**Rezoning Application: PD 26-0560**

**APPLICATION NUMBER: PD 26-0560**

## AGENCY REVIEW COMMENT SHEET

**FW: RZ-PD 26-0560 - Design Exception Review**

**2.4 Proposed Site Plan** (partial provided below for size and orientation purposes. See Section 8.0 for full site plan)

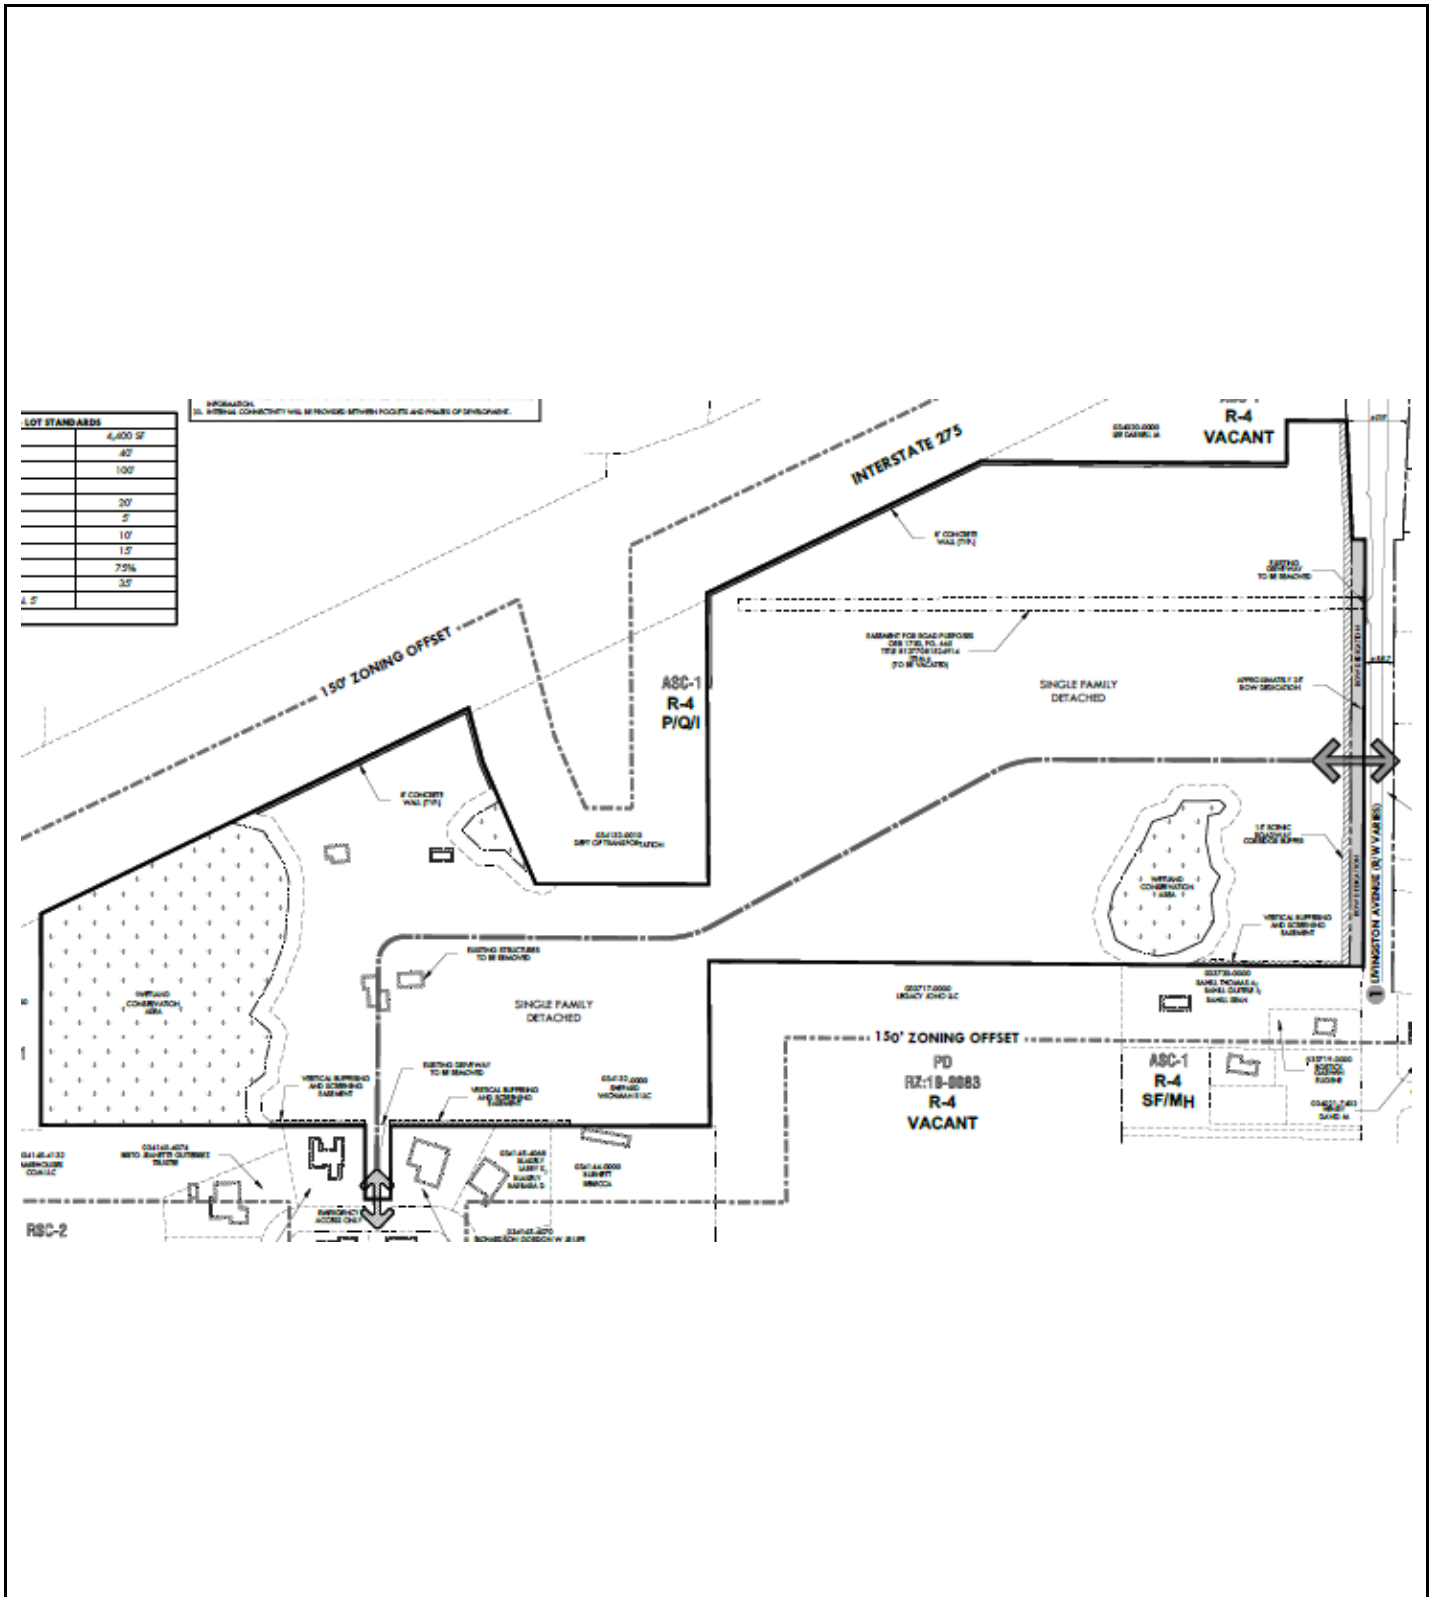
Prior to site plan certification, the applicant shall complete the following:

1. Revise "150' Zoning Offset" to "150' Study Area".
2. Provide a +/-14-foot-wide strip of land along the Livingston Ave frontage of the northern +/-515 feet of folio 34020.0000 labeling it "+/-14 Feet of Right-of-Way Preservation per Hillsborough County Corridor Preservation Plan."

3. Revise the 25-foot-wide right of way dedication along Livingston Ave to provide 20 feet of right of way conveyance and 10 feet of right of way preservation, in accordance with the Design Exception found to be approvable.

4. Label the 10-foot-wide Corridor Preservation Area as "+/-10 Feet of Right-of-Way Preservation per Hillsborough County Corridor Preservation Plan."
5. Label the 20-foot-wide dedication area as "+/-20 Feet of Right-of-Way Foot Right-of-Way Conveyance Area - See Conditions of Approval."

6. Revise the Site Plan Project Data Table from "Total Dwelling...: 130 units" to "Total Dwelling...: 86 units".
7. Revise Gross Density from "2.8 du/acre" to "1.9 du/acre".

8. Revise the Single Family Detached Lot inset map to increase the lot width to 60'.
9. Revise the Single Family Detached Lot Standards table "Min. Lot Width: 40'" to "Min. Lot Width: 60'".

10. Revise the Single Family Detached Lot Standards table "Min. Lot Size 4,400sf" to "Min. Lot Size 6,000 sf".

Figure 3: Proposed Typical Section

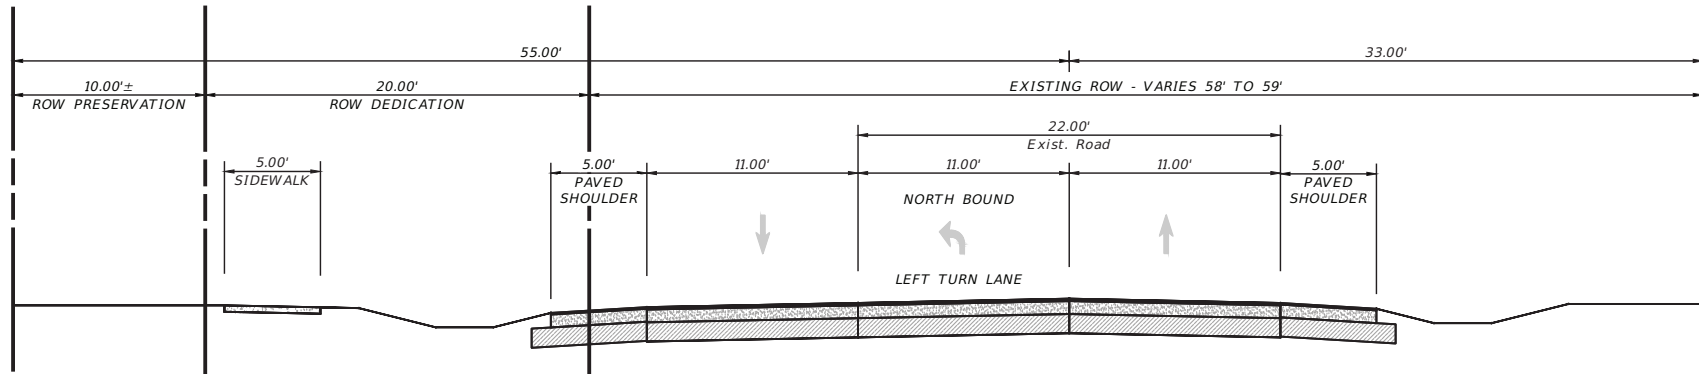
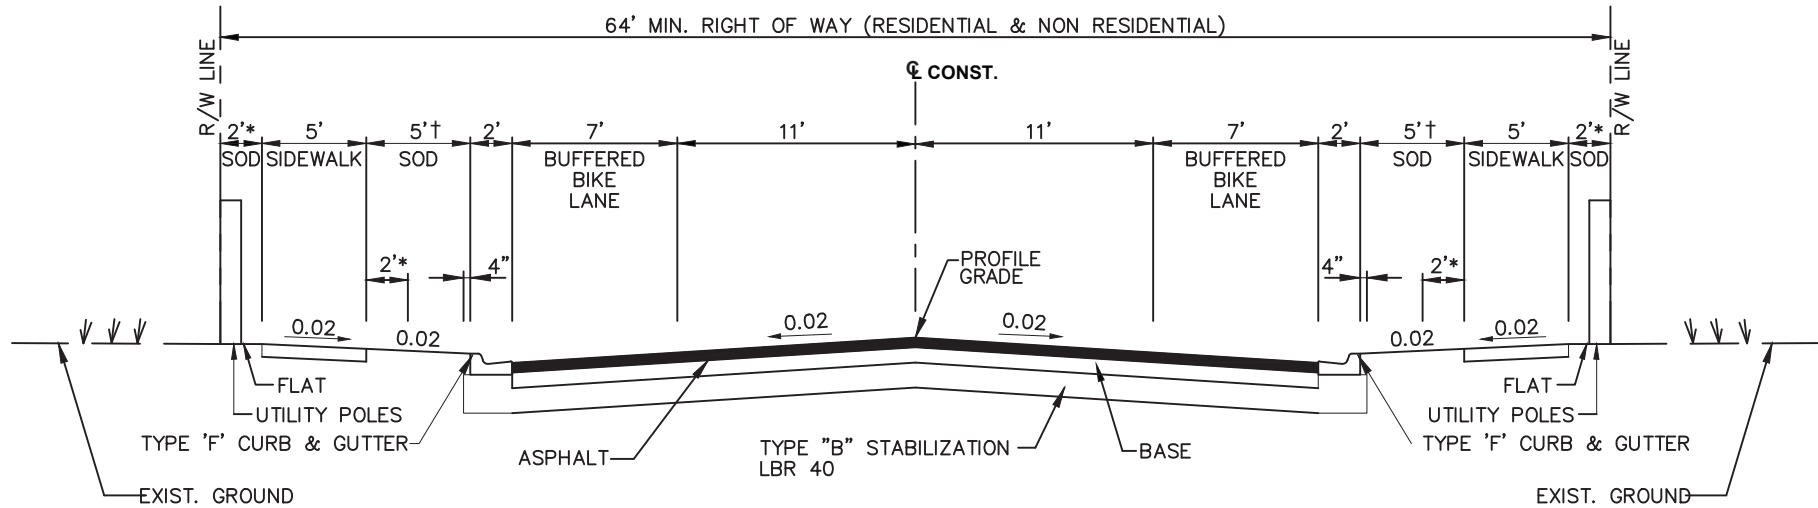
1. The TS-4 includes 11-foot travel lanes. The request is to provide the 11-foot travel lanes and an 11-foot northbound left turn lane. According to the Florida Green Book, on a suburban roadway where the speed limit is between 40 and 45 mph, 11-foot travel and auxiliary lanes may be used. The post speed limit on Livingston Avenue is 40 mph.
2. The TS-4 includes a 7-foot buffered bike lane. The request is to provide a 5-foot paved shoulder in lieu of the buffered bike lane on both sides of the roadway along the property frontage outside the FDOT Limited Access ROW. The paved shoulder can serve as a bicycle lane.

3. The TS-4 incorporates an F type curb. Given this section of Livingston Avenue does not have an F type curb within the immediate area, it is requested to maintain the existing section without an F type curb.

4. The TS-4 section includes a 5-foot grass strip between the sidewalk and the curb. The request is to provide an open ditch section between the paved shoulder and the sidewalk/ROW line. The side slopes on the ditch will be a maximum of 1:4. Additionally, the ditch depth will not exceed 3.5 feet.

5. The TS-4 section includes a 5-foot sidewalk on both sides of the roadway. The request is to provide a 5-foot sidewalk on the west side of the roadway along the property frontage outside the FDOT Limited Access ROW.

6. The TS-4 includes 2 feet from back of sidewalk to the right of way line. This will be provided along the western side of the roadway.
7. The TS-7 requires a minimum of 64 feet of ROW. The existing ROW adjacent to the project is approximately 58 feet. Based on the proposed improvements, the request is to provide a dedication of approximately 20 feet of ROW along the project frontage, with an additional 10 feet of ROW preservation.

- provide an 11-foot-wide northbound left turn lane; and
- provide a 5-foot-wide paved shoulders on both sides of the roadway; and
- provide an open ditch section between the paved shoulder and sidewalk on the west side of the roadway, and the paved shoulder and right of way line on the east side of the roadway; and
- provide a 5-foot-wide sidewalk on the west side of the roadway outside of the FDOT Limited Access Right of Way
- provide 2 feet between the back of the sidewalk and the dedicated right of way line; and
- dedicate +/- 20 feet of right of way along the project frontage outside of the FDOT Limited Access Right of Way; and
- preserve 10 feet of right of way in addition to the above noted dedication.

I have found the attached Design Exception (DE) for PD 26-0560 APPROVABLE.
